C. Amendments to the drawings:

REMARKS

Fig. 9

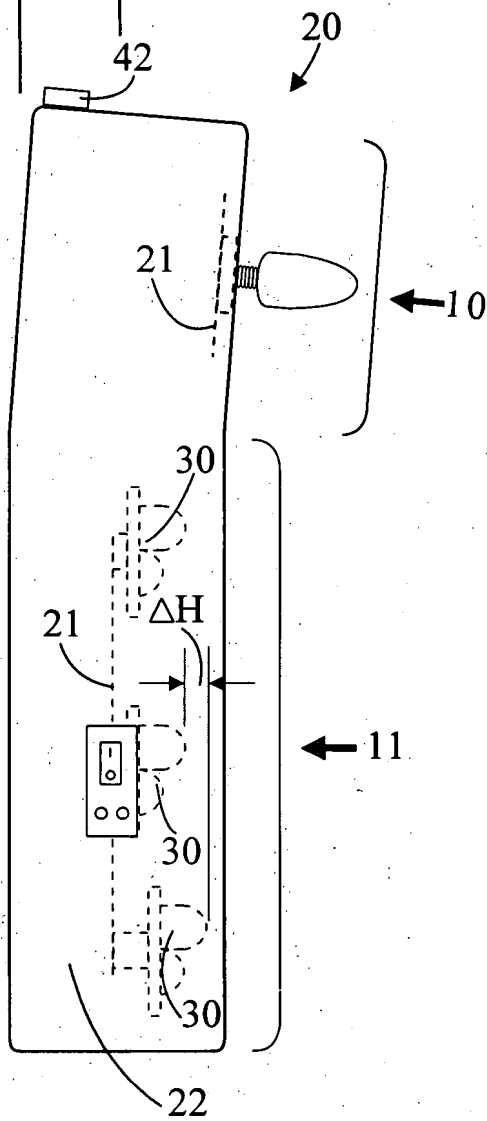
said lowest pair of back massage heads raised a distance ΔH from said other pairs of back massage heads.

Referring to FIG. 9 and the associated discussion, the lowest pair of back massage heads are raised a distance ΔH from the other two (upper) pairs of back massage heads. This offset feature of the present invention causes the lowest pair of back massage heads to conform to the inward curvature of the user's lower spine and resultantly relaxes muscles around vertebrae 1L through 5L.

Fig. 10

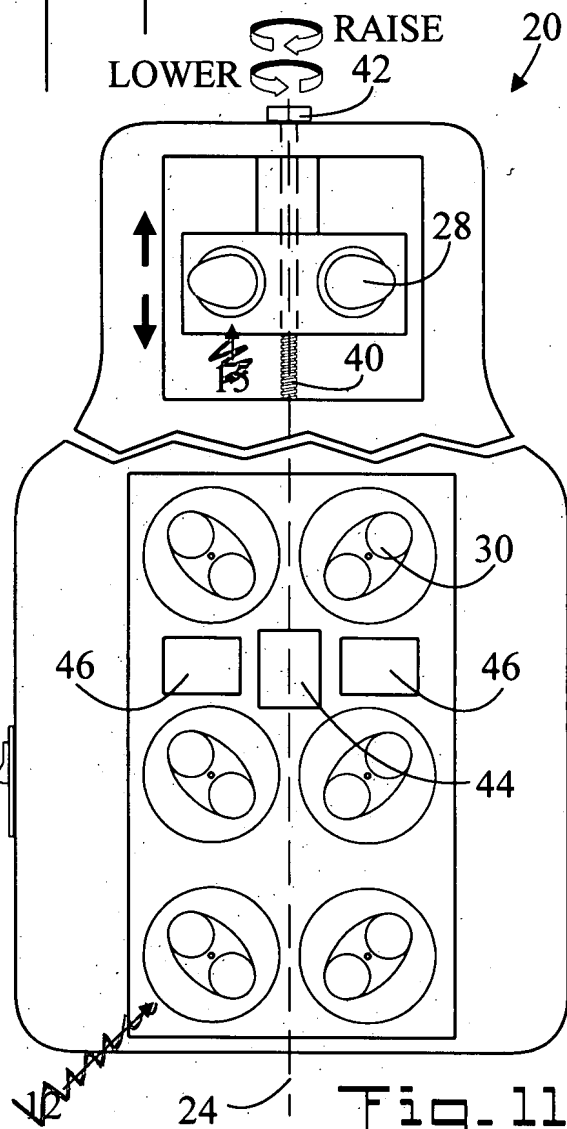
Please replace existing drawing sheet 4/8 with replacement drawing sheet 4/8 included herein. On drawing sheet 4/8, FIG. 10 has been amended to delete reference numeral 15, and FIG. 11 has been amended to delete reference numeral 12.

The drawings are objected to as failing to comply with 37 CFR 1.84(p)(5) because they include the following reference character(s) not mentioned in the description: 12 and 15. . .

The Applicant has amended FIGs. 10 and 11 of drawing sheet 4/8 to remove reference numerals 15 and 12 respectively. Both replacement and annotated sheets 4/8 are included herein.

Fig. 16

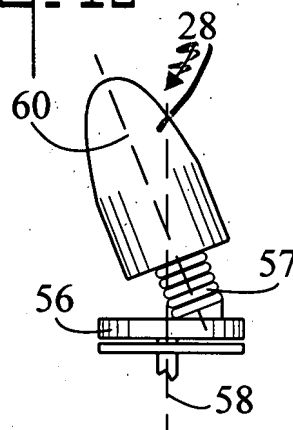
Please replace existing drawing sheet 5/8 with replacement drawings sheet 5/8 included herein. On drawing sheet 5/8, FIGs. 15, 16, and 17 have been amended to modify reference numeral 28.

The Applicant respectfully requests that the Examiner revisit the rejection of Claim 4. Claim 4 has been reworded and rewritten in independent form to include the following limitation:
said neck massage head having a central axis which outwardly projects from said rotating unit toward said rotational axis.

Referring to FIGs. 16 and 17, it is noted that in the present invention the central axis 60 of the neck massage head 28 outwardly projects from rotating unit 56 toward rotational axis 58. That is, central axis 60 angles toward rotational axis 58. In fact, the two axes actually cross within the body of neck massage head 28.

FIGs. 15-17 on drawing sheet 5/8 have been amended to correct the placement of reference numeral 28 (neck massage head). Both replacement and annotated sheet 4/8 are included herein.
